UNITED STATES PATENT AND TRADEMARK OFFICE

APPLICATION NO.	FILING DATE	FIRST NAMED INVENTOR	ATTORNEY DOCKET NO.	CONFIRMATION NO.
10/762,772	01/22/2004	Stephen W. Briggs III	BBMED.004A	3108

Office Action Summary	Application No. 10/762,772	Applicant(s) BRIGGS, STEPHEN W.	
	Examiner Teena Mitchell	Art Unit 3743

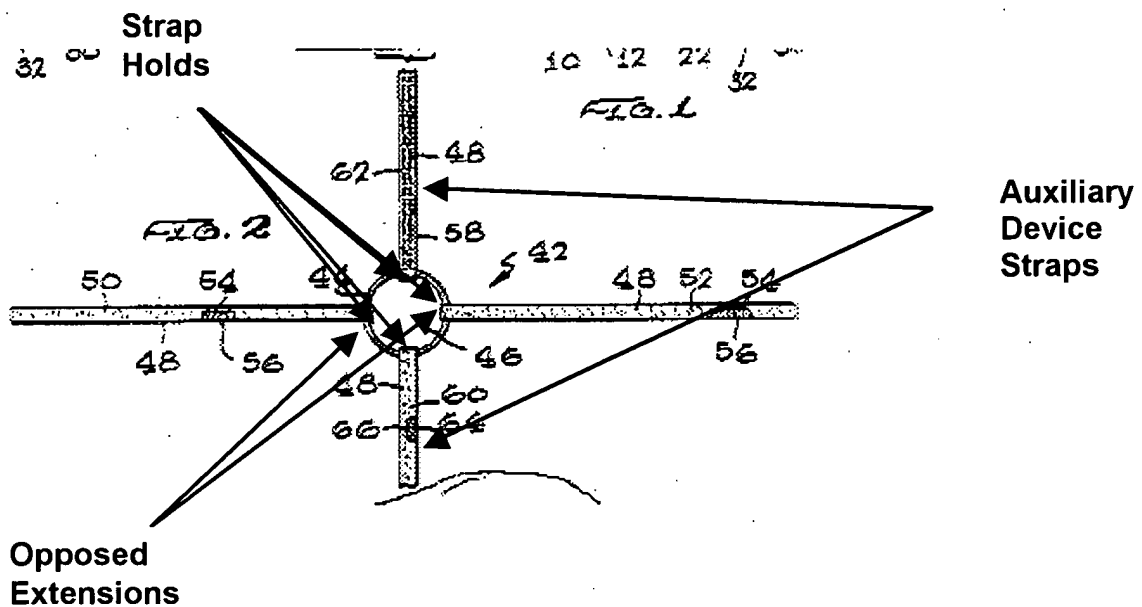
- a ring (44) having a pair of opposed extensions defining strap holds (Col. 3, lines 36-48), and further having a pair of secondary strap holds (see illustration of Fig. 2 below); a void (46) within the ring (44) configured to allow passage of a tracheostomy tube (38) through the ring (44);

- a pair of auxiliary device straps (see illustration of Fig. 2 below) affixed to each of the secondary strap holds, the auxiliary straps configured so that when the tracheostomy tube extends through the ring void (46), the auxiliary straps extend around an auxiliary device (40) that is fit onto the tracheostomy tube (Fig. 5) so as to maintain a maximum spatial relationship between the auxiliary device and the ring (44).

With respect to claim 12, Briggs discloses a ring (44) having an aperture (46), a pair of opposed primary strap holds, and a pair of secondary strap holds (see illustration of Fig. 1 above); and a pair of auxiliary device straps affixed to each of the secondary strap holds, the auxiliary straps configured so that, when the tracheostomy tube extends through the ring void, the auxiliary straps can extend around an auxiliary device that is
